RE: 2 Russell St
Meeting: HDC 08/10/22
Packet Pages: 132-223

RE: 161 Deer St
Meeting: HDC 08/10/22
Packet Pages: 280- 312

RE: 1& 31 Rayens, 203 Maplewood

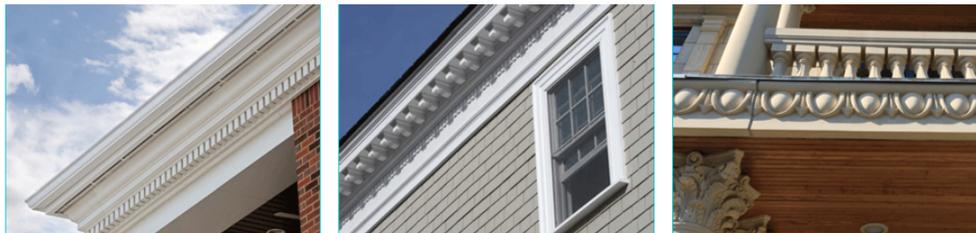
Upon reviewing and comparing July and August the entrances look a lot like something one might see when going to the local movie theater, lots of flat glass, especially the hotel entrance. These are HUGE buildings, perhaps some wood, metal work or bricks with some three dimensional designs could be added next to the entrance doors. **Existing:**
